Access Compliance Report Public Rights-of-Way (Curb Ramps)

Intersection ID: 13586 Main Street: E_7TH_ST **Cross Street: ARMORY DR** Location: W **ADA ID: 7EBBCF85E651** Ramp Type: Directional1 Initial Pass/Fail: Pass **Overall Compliance: No Severity Score:** 17.5

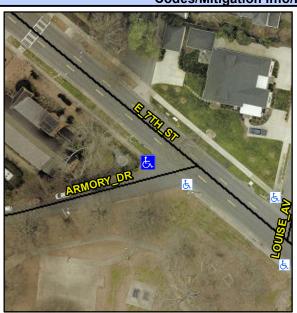
ARMORY DR Street 1 Name StopSign Stop Condition-Street 1 Street 2 Name N/A Stop Condition-Street 2 N/A Possible Solutions: Remove & Replace Entire Ramp. Grind Gutter Lip. Surveyor Notes: N/A PROW/ADA: R304.2.2-Perp, R304.3.2-Para, R304.5.3, R304.5.2, R305, R302.7.2

Field Measurements/Component Compilance					
Compliance Description		Data	Compliance Description		Data
N/A	Ramp Length (in)	64.0	No	Grade Break?	No
Yes	Ramp Width (in)	63.0	N/A	Grade Break Slope (%)	N/A
Yes	Ramp Slope (%)	6.1	N/A	Grade Break XSlope (%)	N/A
Yes	Ramp XSlope (%)	1.2			
N/A	Flare Type LT	N/A	N/A	Flare Type RT	N/A
Yes	Flare Slope LT (%)	3.7	N/A	Flare Slope RT (%)	5.8
N/A	Flare Traversable LT?	Yes	N/A	Flare Traversable RT?	No
Yes	Landing Length (in)	60.0	No	DWS Provided?	No
Yes	Landing Width (in)	69.5	N/A	DWS Contrast?	No
No	Landing Slope (%)	2.9	N/A	DWS Length (in)	N/A
No	Landing X Slope (%)	2.4	N/A	DWS Full Width?	No
N/A	Landing Curb? (Y/N)	N/A	N/A	DWS Offset LT (in)	N/A
N/A	Shared Landing?	No	N/A	DWS Offset RT (in)	N/A
Yes	Gutter Ponding?	No	Yes	Gutter Slope (%)	1.3
No	Gutter Lip Ht (in)	0.3	Yes	Gutter X Slope (%)	0.2
N/A	Painted X Walk1?	No		Road Slope (%)	2.5
	X Walk 1 Direction	To SE		Road X Slope (%)	2.1
